**DOCUMENT 00 90 00**  
**ADDENDUM**

**ADDENDUM No.:** 2

**DATE:** April 1, 2025

**RE:** WESTERN TECHNICAL COLLEGE  
STUDENT SUCCESS CENTER RENOVATION  
400 N. 7TH STREET  
LA CROSSE, WISCONSIN 54601

A090

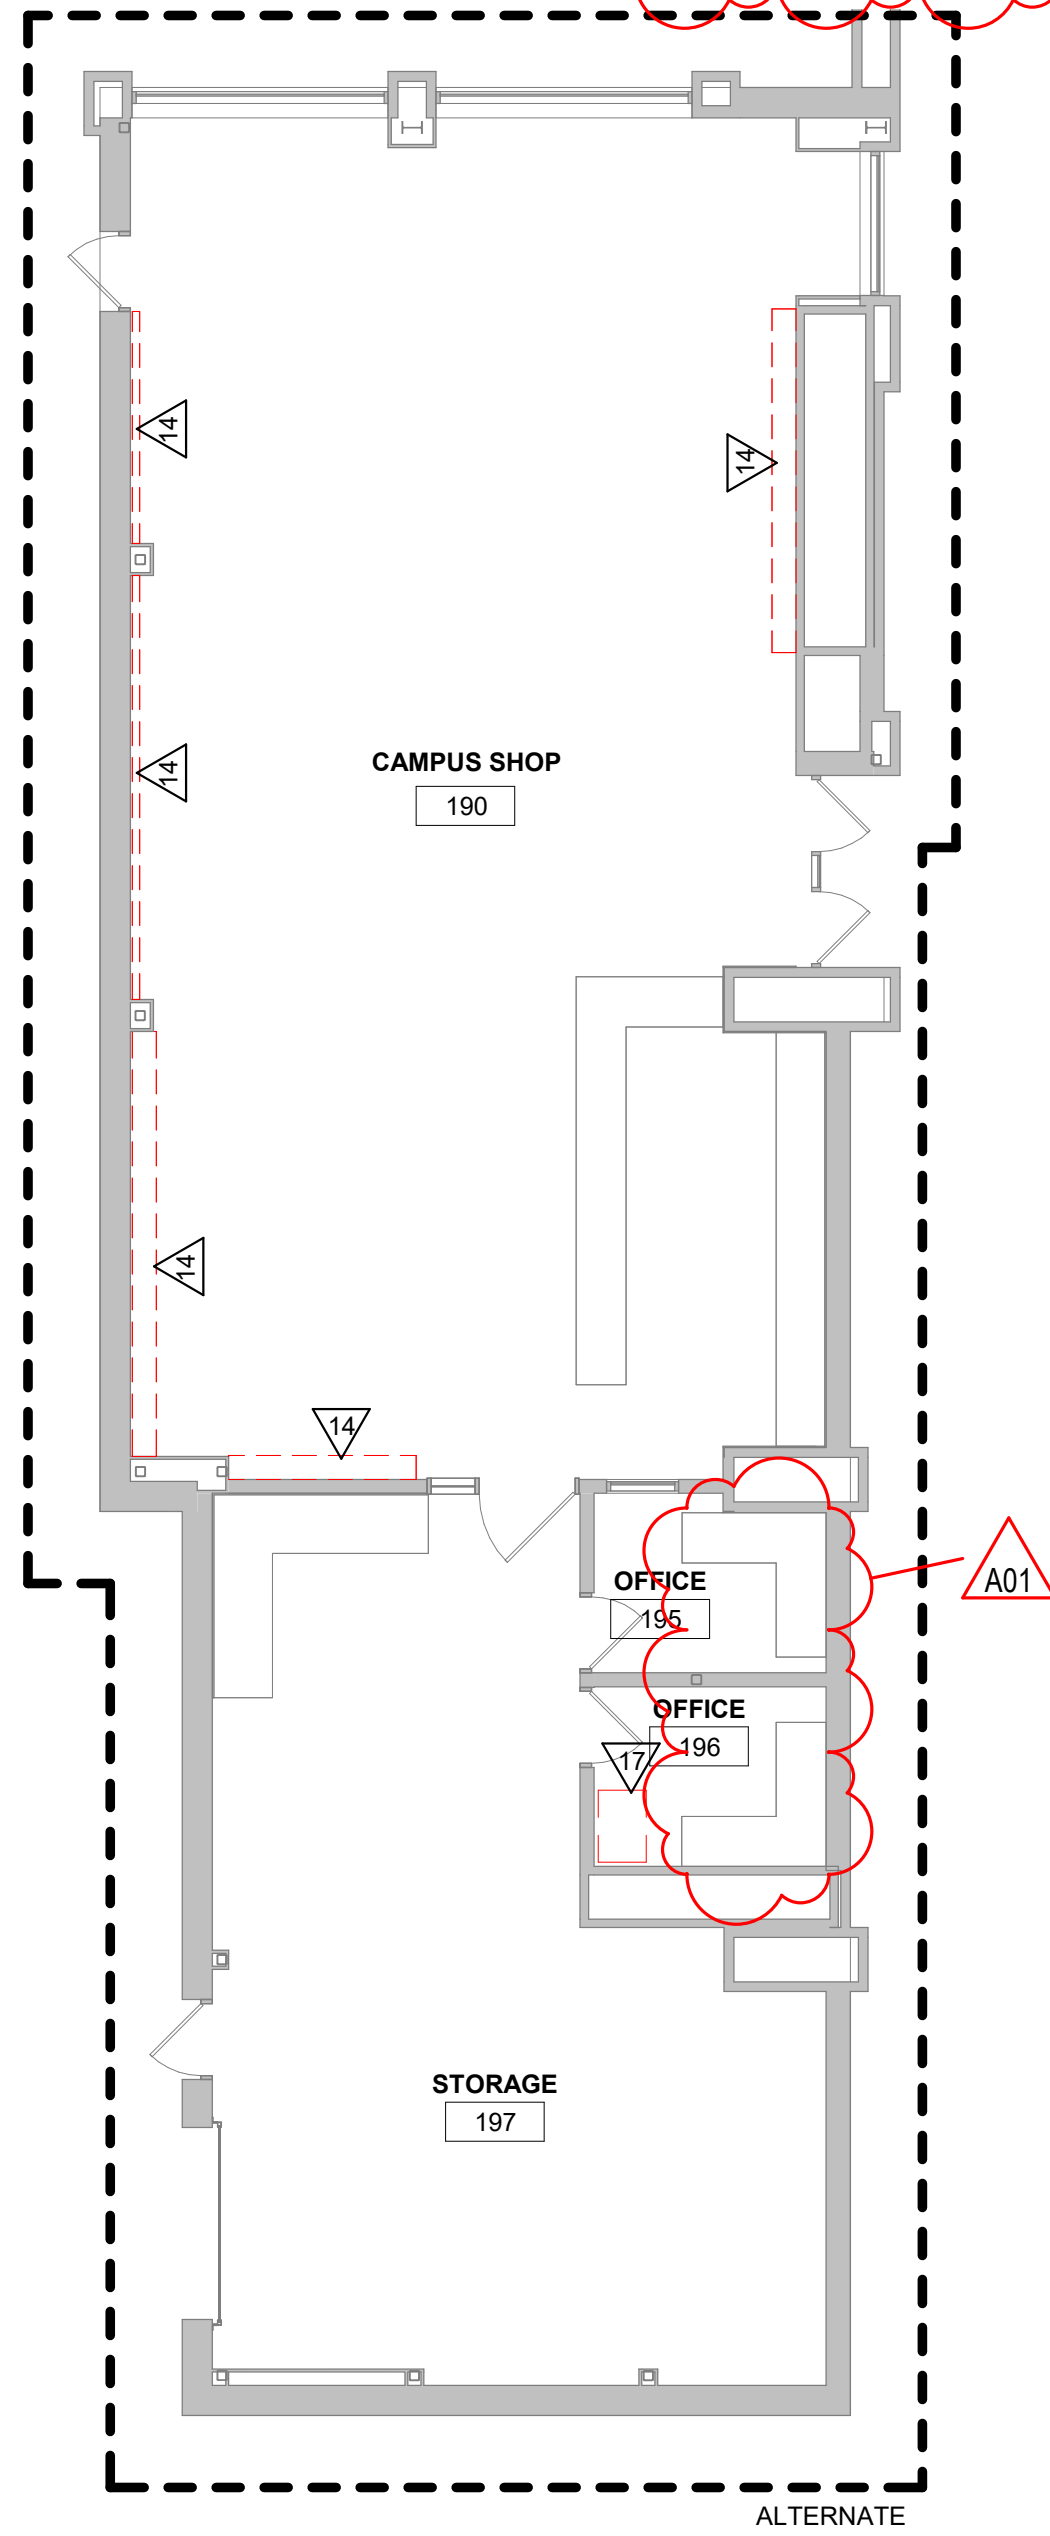
2. Sheet A090 DEMOLITION FIRST FLOOR 30"x42"
  - a. See the revised sheet included in this addendum. Disregard the previous version.
  - b. 1/A090: Keynote 7 added in Testing 162.
3. Sheet A100 FIRST FLOOR 30"x42"
  - a. See the revised sheet included in this addendum. Disregard the previous version.
  - b. Keynote 9 added.
  - c. 1/A100: Door tag 1H8 added in Corridor 1H8, keynote 9 added in Corridor 1H5, keynote 9 added in LST 155.
4. Sheet A110 FIRST FLOOR REFLECTED CEILING PLAN 30"x42"
  - a. See the revised sheet included in this addendum. Disregard the previous version.
  - b. 1/A110: Ceiling and tag updated in Testing 162.

## WALL TYPES, DOOR SCHEDULE & WINDOW ELEVATION

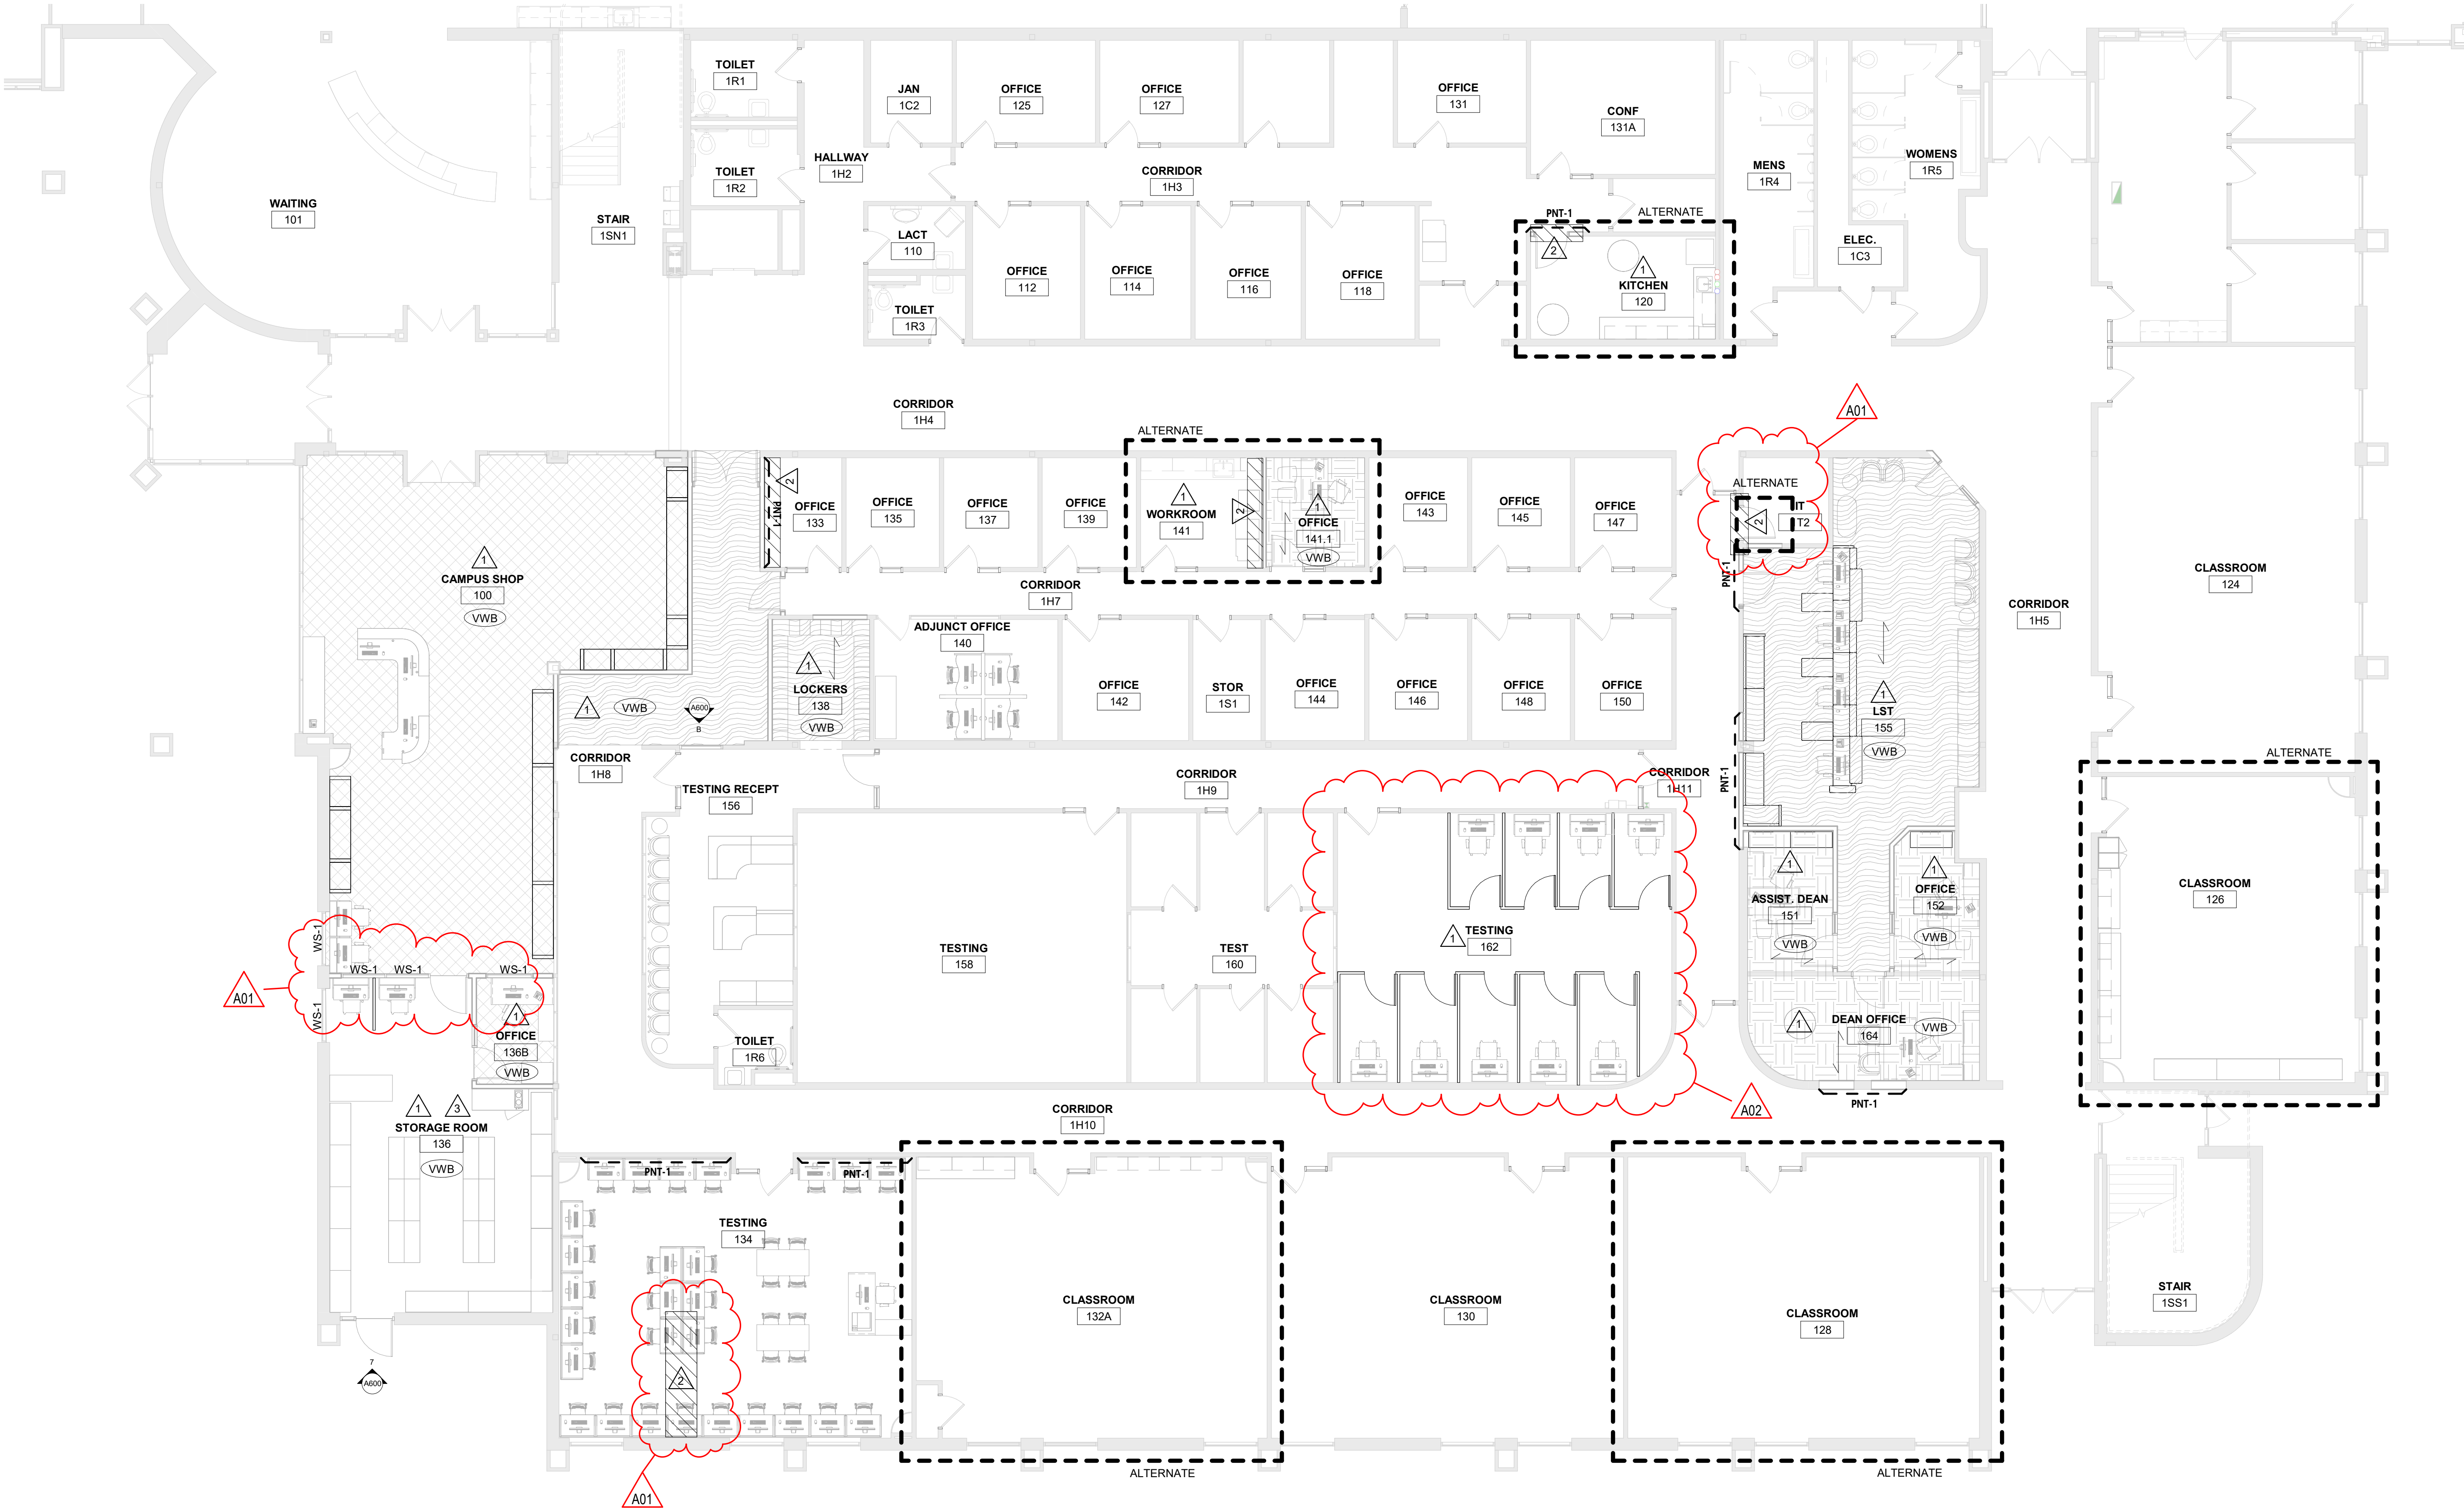
5. Sheet A600 WALL TYPE, DOOR SCHEDULE & WINDOW ELEVATION 30"x42"
  - a. See the revised sheet included in this addendum. Disregard the previous version.

- b. Door Schedule: Door 1H8 added, door 155.1 remarks updated, door 155.2 remarks and hardware group updated.
  - c. Door Schedule Remarks: remark 4 added.

**ID101**

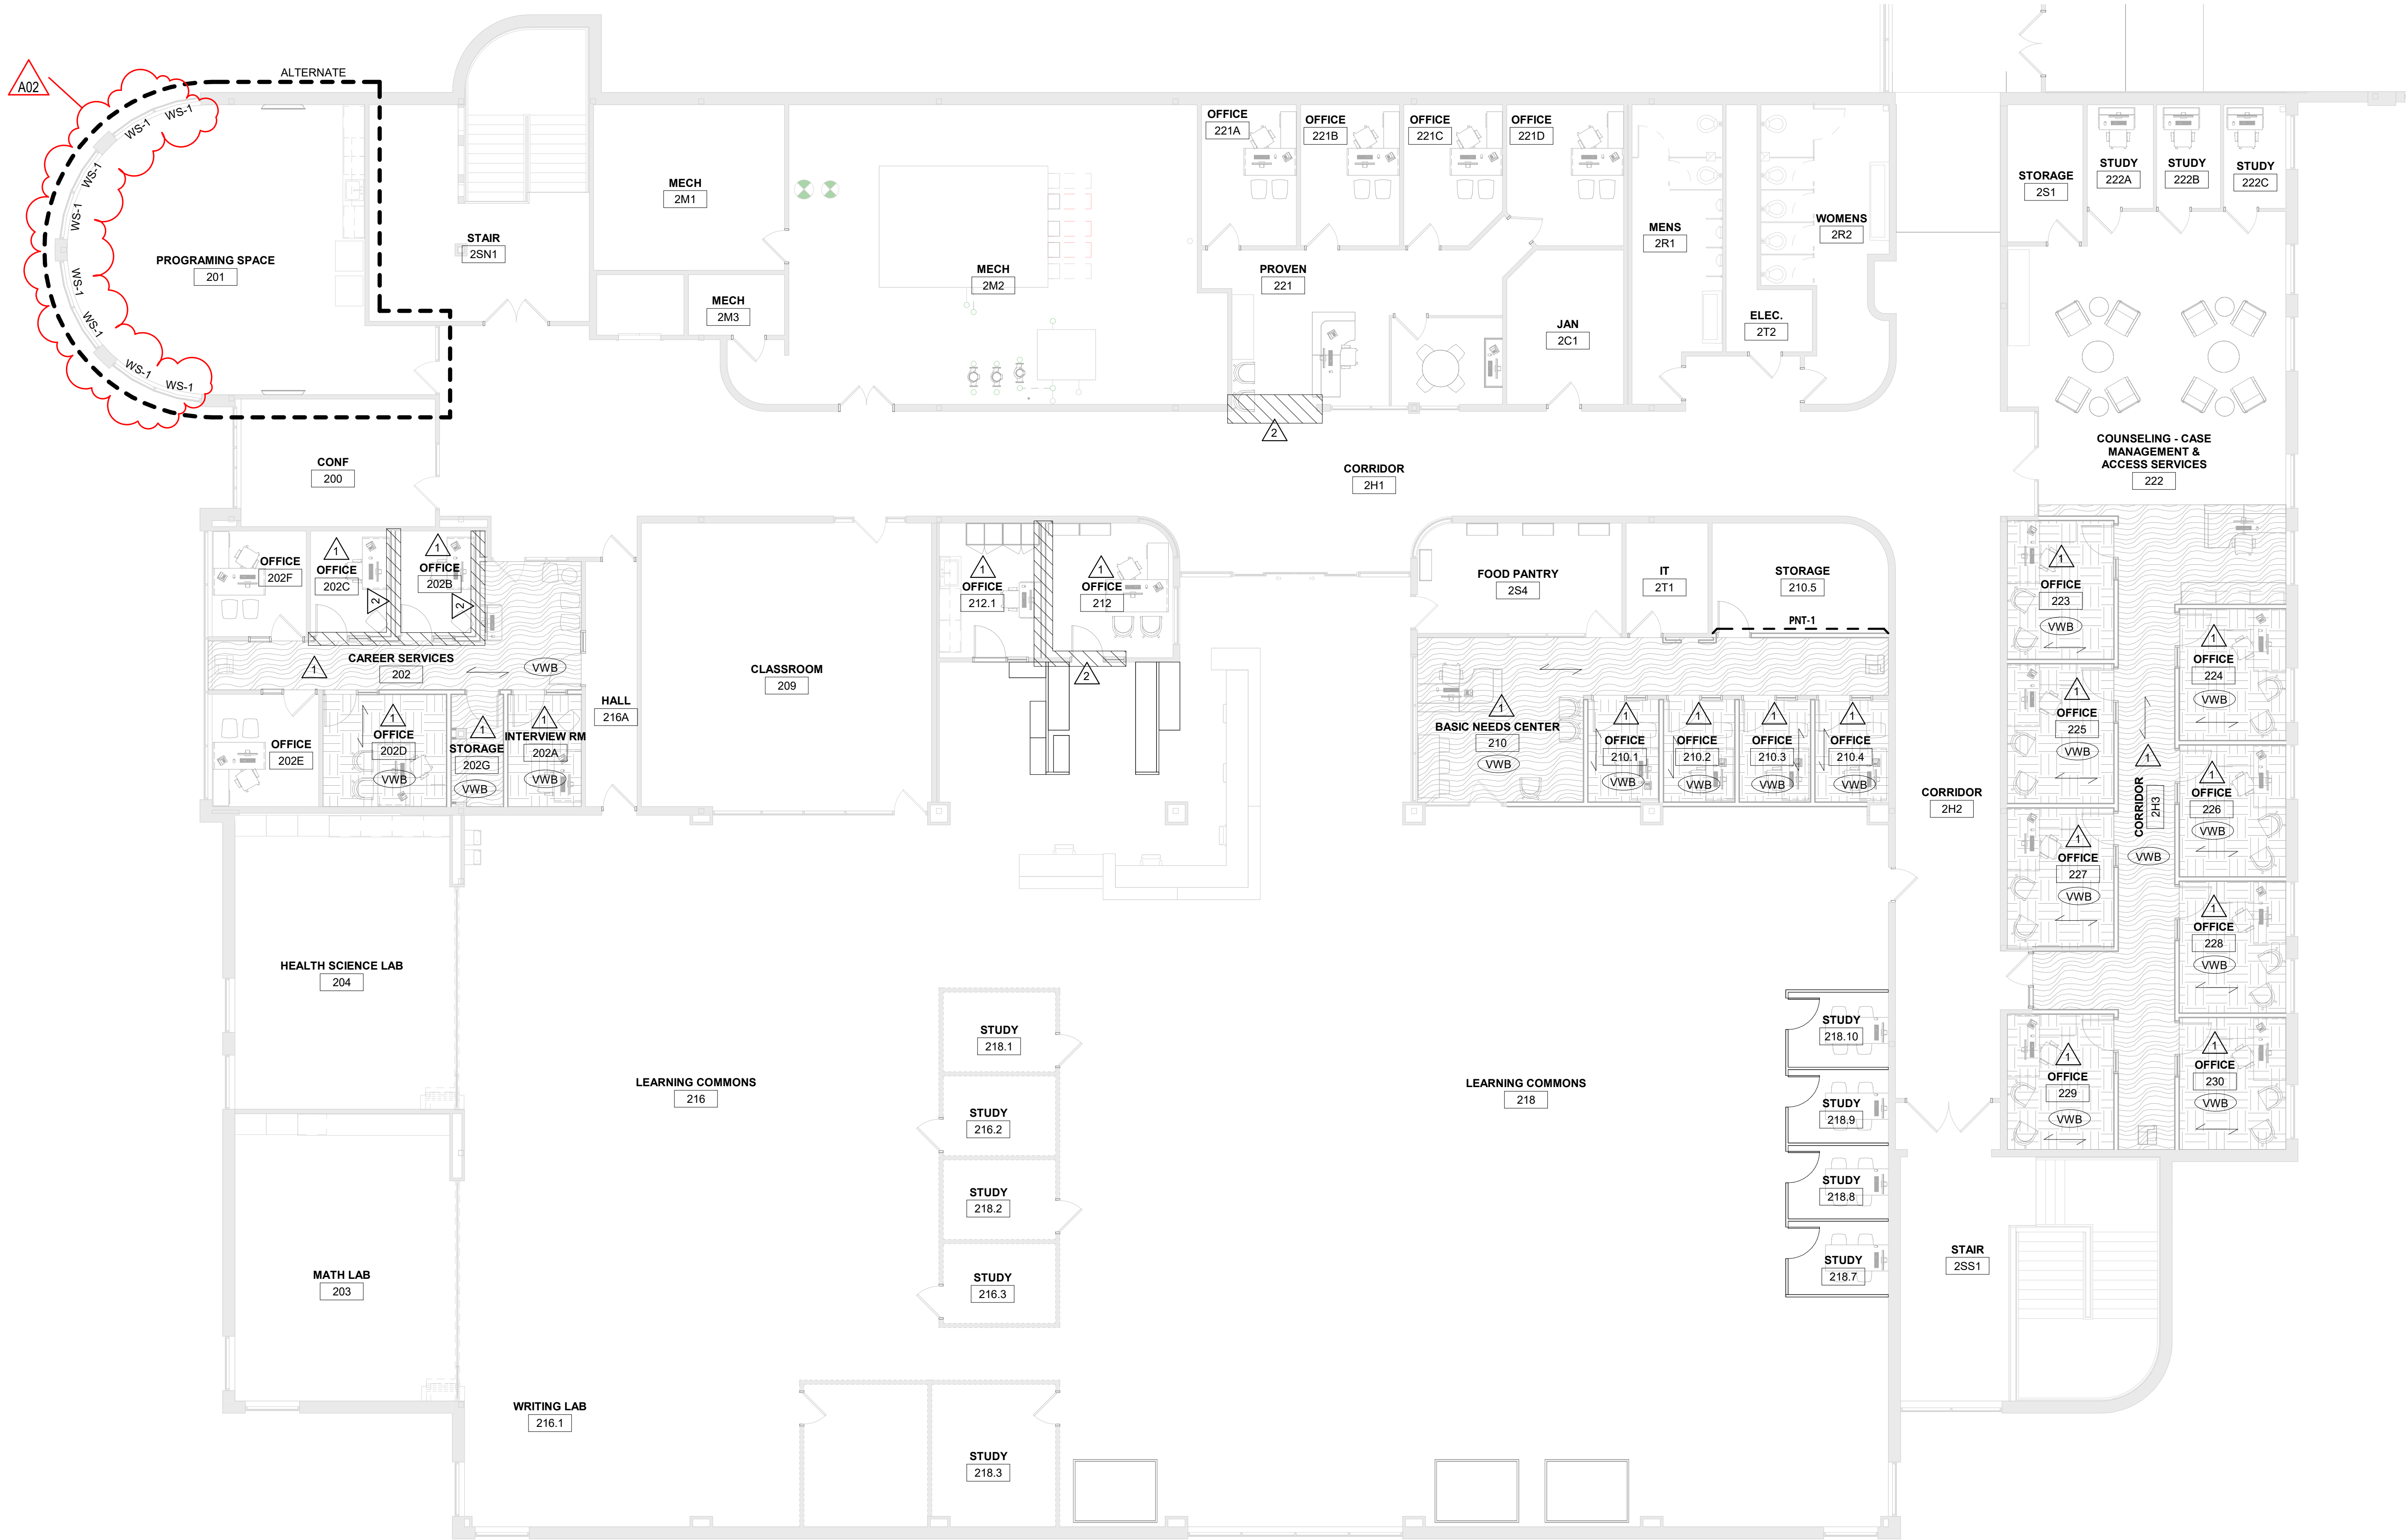
6. SHEET ID101 FIRST FLOOR FINISH PLAN 30"x42"
  - a. See the revised sheet included in this addendum. Disregard the previous version.
  - b. 1/ID101: Keynote 1 added to Testing 162
